PROJECT REVIEW REPORT

<b>Project ID</b>	2401
<b>Project name</b>	Reforestation of Degraded Lands in Sierra Leone
<b>Review Type</b>	Verification Approval
<b>Program(s)</b>	VCS Program
<b>Verification Period</b>	11 January 2020–20 September 2022
<b>Project Proponent</b>	MFSL Developments Ltd.
<b>Methodology</b>	AR ACM0003, Afforestation and reforestation of lands except for wetlands, v2.0
<b>VVB</b>	KBS Certification Services Ltd.
<b>Assessment Criteria</b>	VCS Standard v4.4
<b>Date of First Issue</b>	15 November 2023

<b>Date of Second Issue</b>	17 April 2024
<b>Date of Third Issue</b>	27 July 2024
<b>Review Conclusion</b>	Approved
<b>Date of Final Issue</b>	17 October 2024

**Issue 4.**

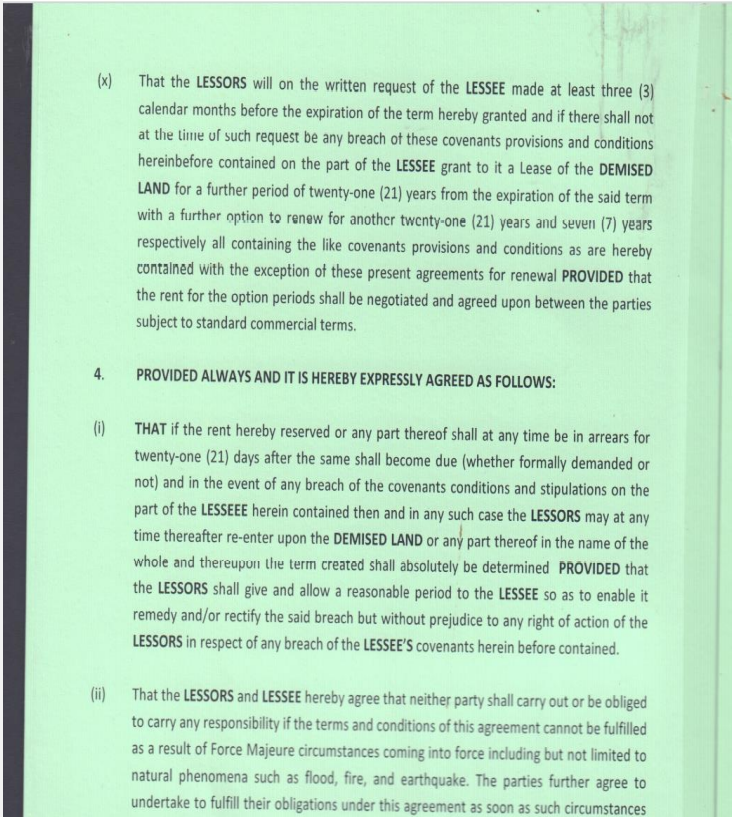
There are references in all the land lease agreements to continue the activity for longer than the first 50 years. The clause states that after the first 50 years “for a further period of twenty-one (21) years from the expiration of the said term with a further option to renew for another twenty-one (21) years and seven (7) years respectively”.

As an example, the following screenshots shows the Mafala land lease agreement<sup>26</sup>:

- Signed on the 13th of October 2020 (First Image),

<ul style="list-style-type: none"> <li>• Section 1. clause(i): Explaining the initial duration of the land lease (21+21+8=50 years)</li> <li>• Section 3. clause (x) : Explaining the renewal process after the first 50 years and the duration of it (21+21+7=49 years)</li> </ul> <p>THIS LEASE AGREEMENT is made this <sup>13<sup>th</sup></sup> day of <sup>October</sup> in the year of Our Lord Two Thousand and Twenty(2020) pursuant to the provisions of the Provinces Land Act (Cap 122) of the Laws of Sierra Leone 1960 as amended (the "Act") <b>BETWEEN THE CHIEFDOM COUNCIL OF YONI MAMELA</b> in the Tonkolili District in the Northern Province of the Republic of Sierra Leone represented by the <b>REGENT CHIEF PA KAPRR SANKA KOROMA</b> (hereinafter referred to as the "GRANTORS" which expression shall include their successors in office) of the first part and <b>OSMAN SESAY, SALLIEU KAMARA, and AMADU KAMARA</b> all of Mafala Yoni Mamela Chiefdom, Tonkolili District in the Northern Province aforesaid on behalf of the <b>MAFALA</b> landholding families (hereinafter referred to as the "LANDOWNERS") of the second part (the <b>GRANTORS</b> and <b>LANDOWNERS</b> hereinafter collectively referred to as the "LESSORS" which expression where the context so admits shall include their successors, beneficiaries and lawful assigns) AND <b>MIRO FORESTRY (SL) LIMITED</b> a limited liability Company incorporated under the Companies Act No. 5 of 2009 with its registered address at C/O First Corporate Services, 35 Liverpool Street, Freetown, Sierra Leone in the Western Area of the Republic of Sierra Leone aforesaid (hereinafter referred to as the "LESSEE" which expression where the context so admits shall include its successors in title and lawful assigns) of the other part.</p>

<p>Therefore, the projects is able to prove and guarantee the longevity for a period of 99 years. The following changes has been done both in the NPRT<sup>28</sup> and Report<sup>29</sup>:</p> <ul style="list-style-type: none"> <li>● In opportunity cost section i) <i>Mitigation: Project is protected by legally binding commitment to continue management practices that protect the credited carbon stocks over at least 100 years (see project longevity)</i> the value has changed from -8 to 0 to give a final value for the opportunity costs of -2.</li> <li>● In the project longevity section the following questions have been changed giving a final value of 4 (See Image below):             <ul style="list-style-type: none"> <li>○ Does the project have a legally binding agreement that covers at least a 100 year period from the project start date? It has been changed from YES to NO</li> <li>○ What is the project Longevity in years? 99 years</li> <li>○ Legal Agreement or requirement to continue management practice? It has been changed from YES to NO</li> </ul> </li> </ul>

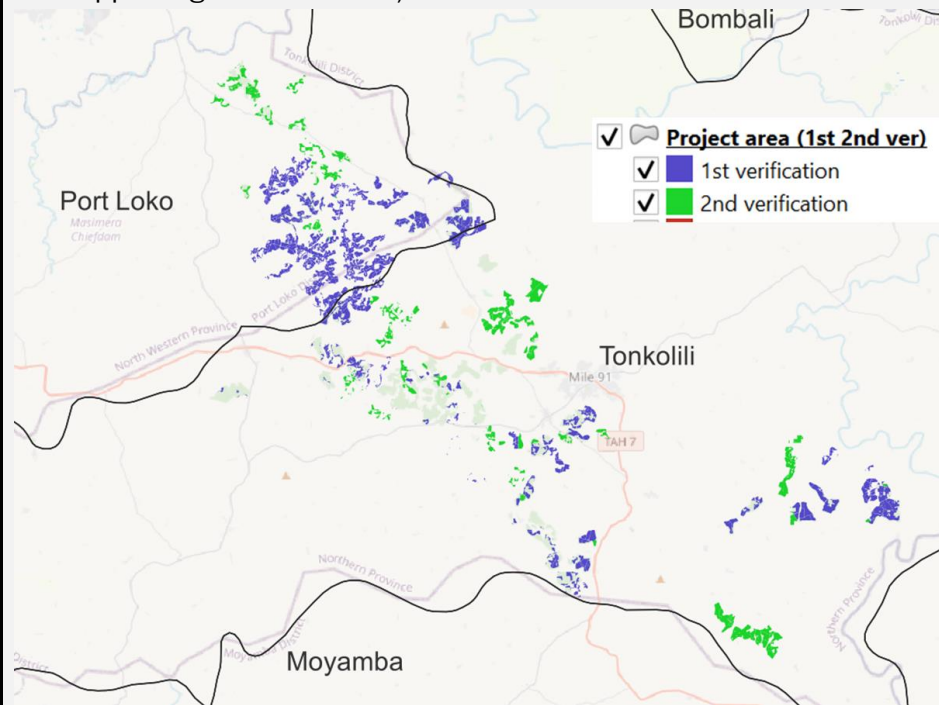
<p>2. The VVB must assess the information in #1, #2, #3 and #4 and ensure the MR and the VR are updated accordingly.</p> <p>3. The VVB must ensure that relevant sections of the NPRR are updated.</p> <p><u>Program Rule(s)</u>  <i>VCS Standard, v4.4, Sections 3.18.18, 3.18.19, 3.18.17(2) b) c) and 3.19.4</i></p>	<p>areas are identified during the planning phase of operations and designated as conservation zones which are protected to encourage natural regeneration. It is the Company's policy to enable natural recovery and succession of conservation zones, and as such the primary management activity is to protect these areas, removing alien invasive exotics.</p> <p>Based on the desired vegetation classification and status, management plans will be developed annually to remove alien invasive species depending on the infestation levels identified in the Microforest weed management module. This module facilitates the identification of current infestation levels and plans to ensure that these areas are returned to maintenance level.</p> <p>Therefore, there is a very low risk of these species propagating outside of the project area (Action 2).</p> <p>Issue 2          According to the ESIA<sup>59</sup>, the activities for which mitigation measures have been designed are the following:          The development of a community development action plan (CDAP) whose idea is to provide opportunities for welfare improvement. In the image below the measures to achieve it are detailed:</p>

<ul style="list-style-type: none"> <li>✦ The use of improved crop varieties and livestock management practices is to ensure increase agricultural productivity;</li> <li>✦ Improve health standards through the timely provision of quality, affordable and accessible health care services; safe drinking water, improved sanitation and waste disposal;</li> <li>✦ Enhance access to formal education through the establishment /rehabilitation of educational infrastructure and facilities;</li> <li>✦ Youth empowerment schemes</li> <li>✦ Provisions of adult literacy facilities in order to improve adult literacy</li> <li>✦ Provision of training for enhanced organizational, managerial and leadership capacities;</li> <li>✦ Provision of technical and vocational skills training opportunities for the development of middle level manpower;</li> <li>✦ The establishment and effective implementation of a reliable health and safety policy that will adequately address health and safety requirements of MFC (SL) Ltd employees in accordance with established national and international standards;</li> <li>✦ Targeted sensitization and awareness raising on the transmission and prevention of HIV/AIDS ,STDs and Ebola virus</li> </ul> <p>✦ Ensuring the maintenance of an effective communication channel with the beneficiary community through regular meetings of the Community Relations Committee (CRC).</p> <p>For more information in Table 35 of the ESIA it is depicted the list of actions and the annual cost.</p> <p>Furthermore for the workers employed at Miro the following measures for health and safety during the different forestry operations have been offered:</p>
